#### DEVELOPMENT REVIEW BOARD REPORT

MEETING DATE: June 1, 2006			ITEM NO
Case Number/ Project Name	117-DR-2005 7150 East Main Street Add	dition	
LOCATION	7152 E Main Street, west of	Scottsdale Road	
REQUEST	Request approval of a site plan and elevations for an addition to an existing commercial structure Downtown.		
OWNER	Orovan Family Trust 602-266-0550	Engineer	Gervasio & Associates Inc 602-285-1720
ARCHITECT/ DESIGNER	Doug Sydnor Architects and Associates, Inc 480-423-1800	Applicant/ Coordinator	Doug Sydnor Doug Sydnor Architects and Associates, Inc 480-423-1800
BACKGROUND	Zoning.

117-DR-2006 REV: 3/13/2006

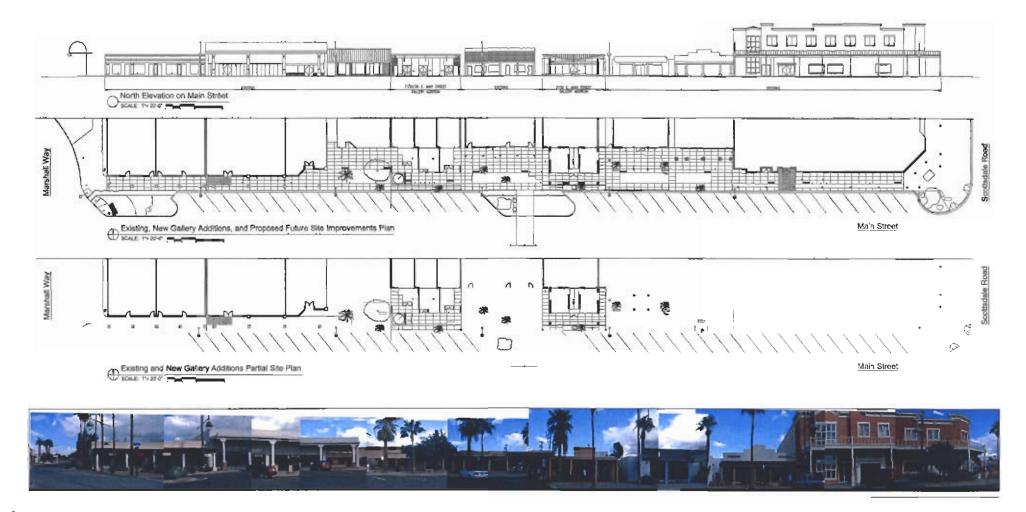
- The existing setback of adjacent galleries and shops is about 30 feet, while the new addition will extend to approximately 12 feet from back of curb.
- The addition is proposed to be set back 5 feet from side property lines to provide access, open space and light to adjoining galleries, staff has stipulated a 6-foot setback for pedestrian access.
- An extension of the roof of the gallery addition provides a canopy covering the sidewalk and pedestrian amenity space.
- The addition contains a more modern and less traditional style than some other local galleries, but is still acceptable within the overall character of the area.
- A modified pedestrian space contains new colored and exposed aggregate concrete finish covered sidewalk, plus landscape area with planters and a bench.

- 6. A minimum of 6-foot clear sidewalk shall be provided on the east and west side of the proposed addition.
- 7. A minimum of 6-foot clear sidewalk shall be provided between the curb and the front of the proposed addition.

A. The building shall be setback 16'-0" from the face of the curb.
